RE: Pinnacle Bellevue North
Project #: 21-103195-LD; 21-103192-LP
Revision Request #1

The Development Review Committee (DRC) has reviewed the plans submitted/dated February 22, 2021. Below are the initial comments and revision requests from the City's review team. **Please note that additional information may be requested as a result of our review of your resubmittal.**

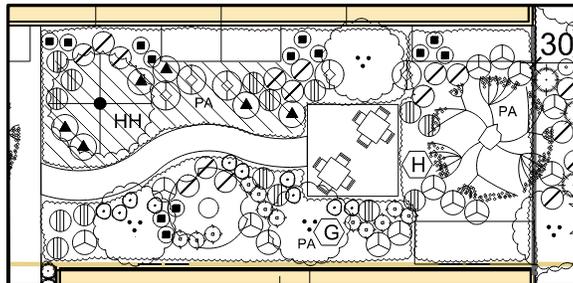
1. Provide dimensioned elevations of each side for all 7 buildings. Here are the submittal requirements: <https://bellevuewa.gov/city-government/departments/development/permits/faqs/plan-review-resources/architectural-plan> Rendered elevations should be in addition to your elevations. Only rendered elevations were submitted, which are not adequate for review. If you need an example of what should be submitted, let me know and I can show you an example.
2. Update all elevation and section drawings to show trigger heights, maximum building height/maximum building height with mechanical, permitted by the applicable perimeter overlay. This should be shown for each building/tower in the project.
Towers 1-3 = Perimeter B-2
Tower4-7 = Perimeter B-1

Any structure (Tower 4?) within Perimeter A-1 will have to meet height requirements of that overlay. We need to ensure each tower is not exceeding maximum building height AND maximum building height with mechanical. You should also include section drawings of garage entry so we can understand the height clearance and how it will be screened from the adjacent public realm.

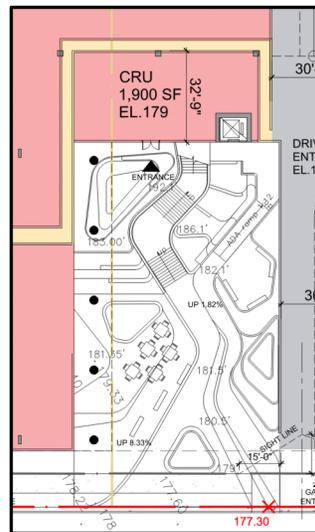
4. Provide additional renderings of this space:

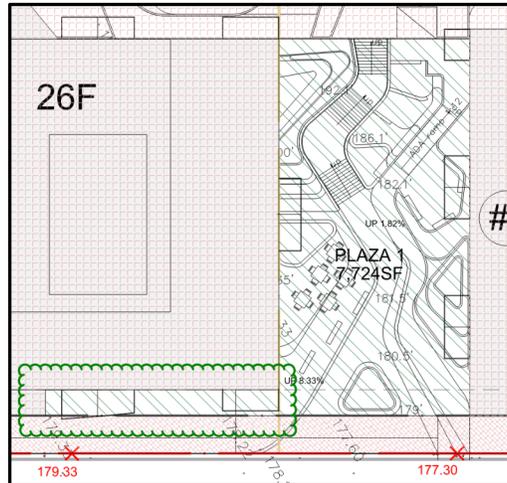
4. In the east plaza area, adjacent to 102nd Ave NE, will there be more useable green space? For example, in the south west corner of the plaza there is a corner of landscaped area, but is this accessible? How is the CRU space accessed in this same area? This plaza contains a lot of hardscape, which is not inviting.

5. The area clouded in green is not part of the east plaza. This is the enhanced streetscape amenity. Remove from outdoor plaza calculation. Consider using as the enhanced streetscape amenity.
